"*Ser Ferndale*" Report No 11660

Revised
1876

S.S. No 225
Scale 1/8" = 1 foot

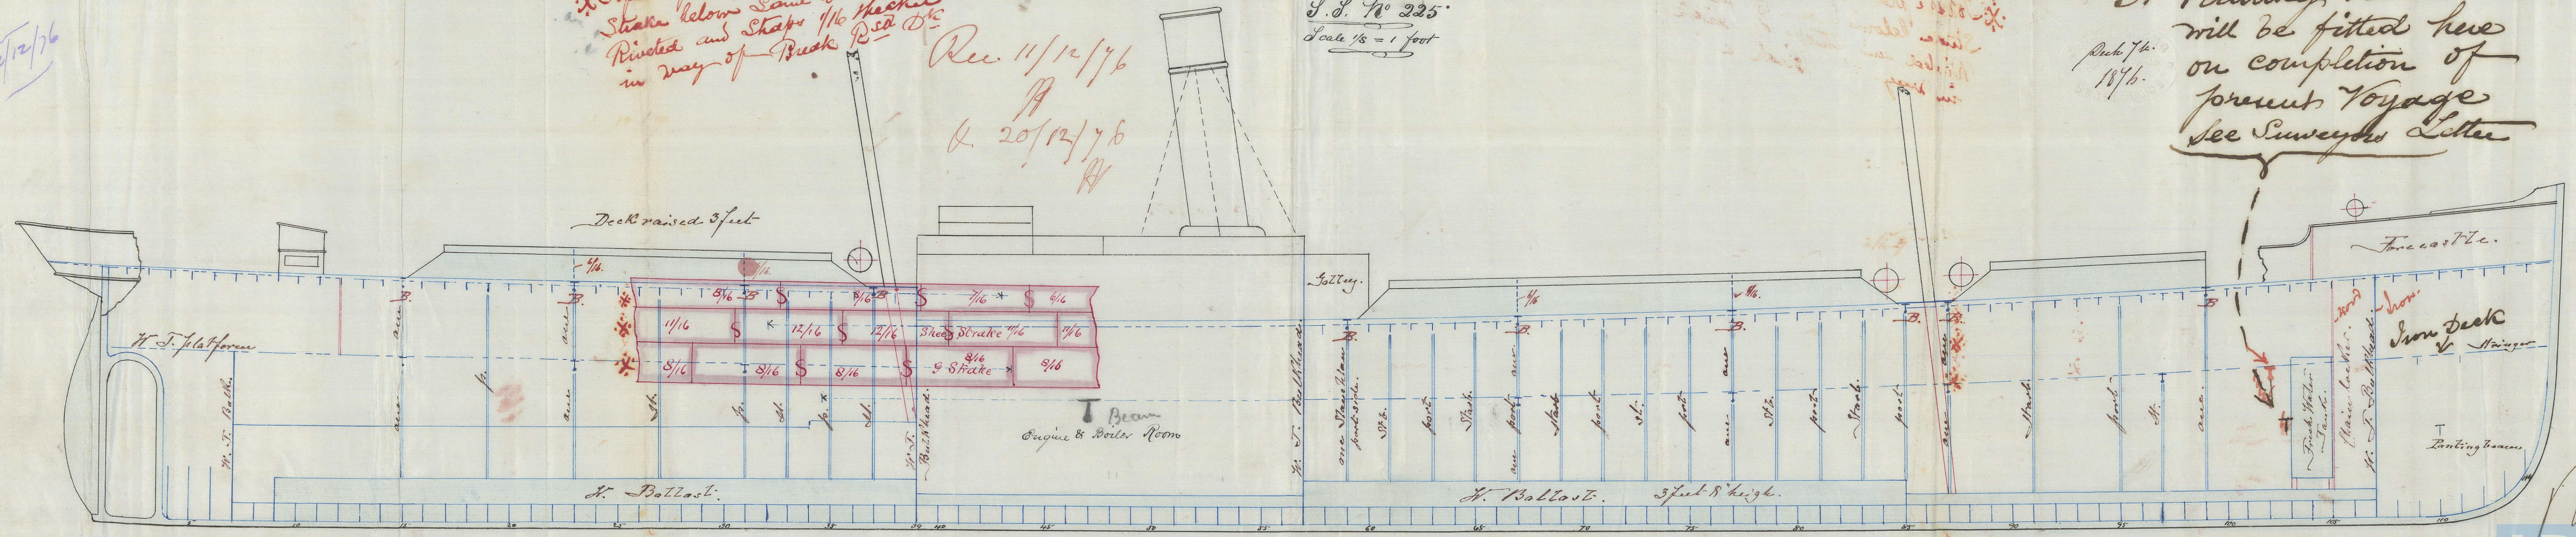
Butts of
* Top side plating, Sheerstrake and
Strake below same to be triple
Riveted and Shaped 1/16 inches
in way of Break Red D

May 1877
A. Pauting Beams
will be fitted here
on completion of
present Voyage
See Surveyor's Letter
